Bulletin Type.....: Safety Recall

Bulletin No.....: TS-S123 (Rev01)

**Bulletin Name.....: Tag Axle Air Bellow Protection
Cover**

Subject: Replacement of bended or deformed tag axle air bellow protection cover.

Figure - 3: Removal of existing air bellow protection covers of tag axle

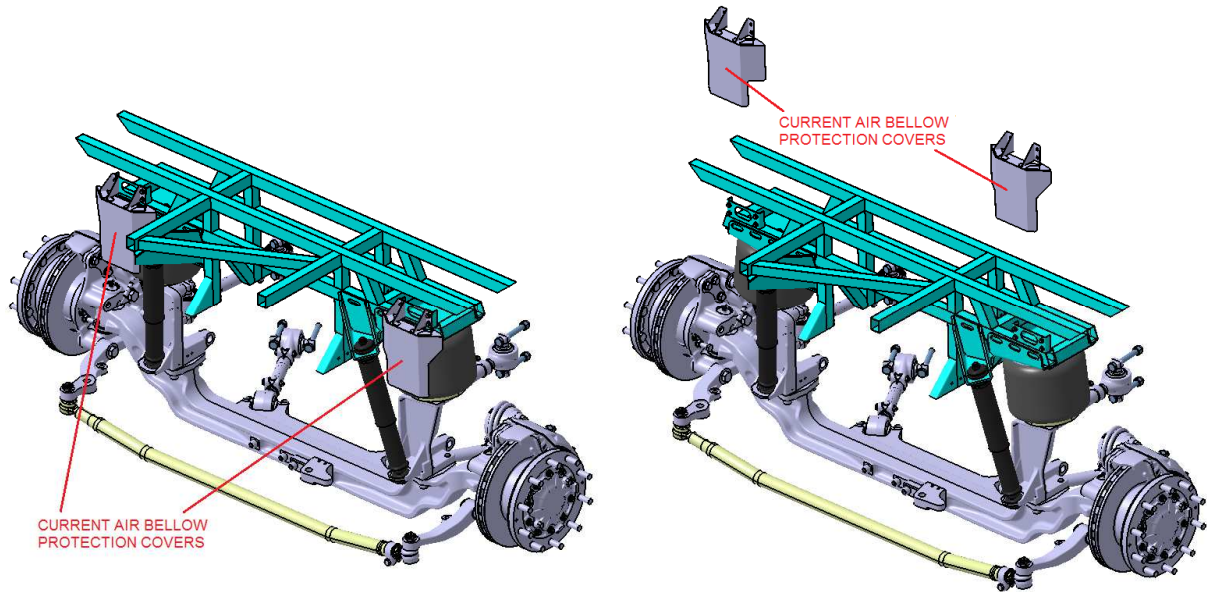
If current air bellow protection covers still exist on the vehicle, remove them by loosening the bolts, (**See Figure-3**)

Figure – 4

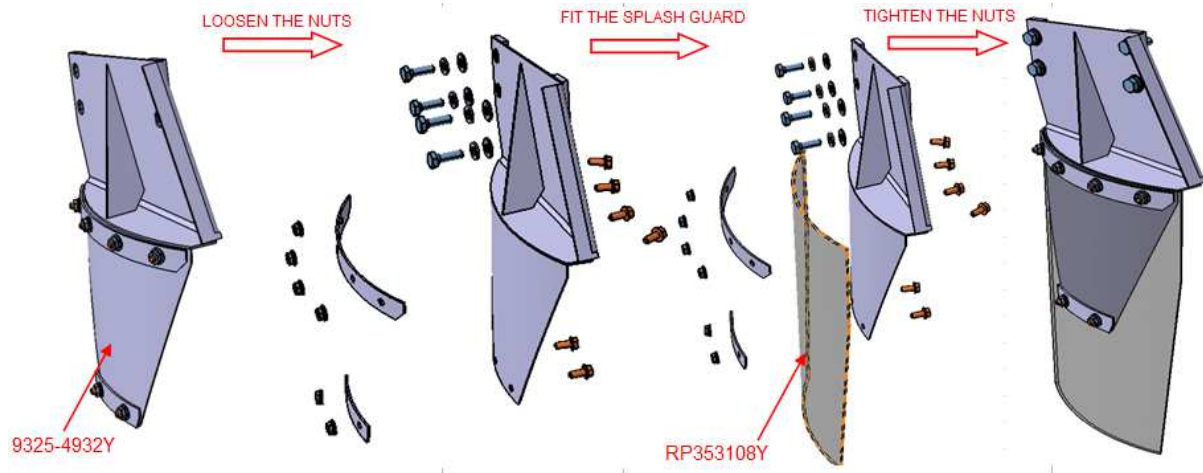
Note: Same subassembly process is also valid for the air bellow protection cover at right side

Figure - 5: Fix the protection cover at left side by the bolts given in DETAIL -A (tightening torque is 8 lbft).

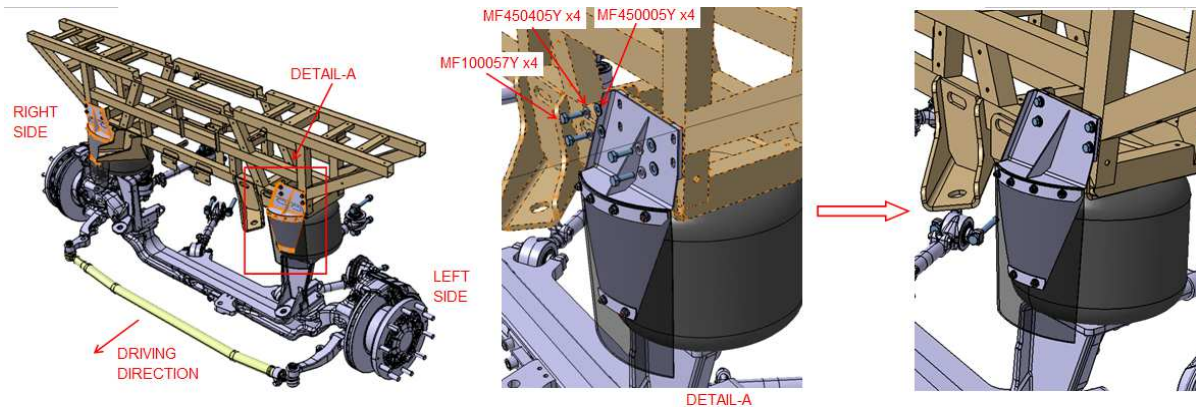
Install both air bellow protection covers to the vehicle, see in **Figure-5** and **Figure-6**.

Note: Same installation process is also valid for the one at right side
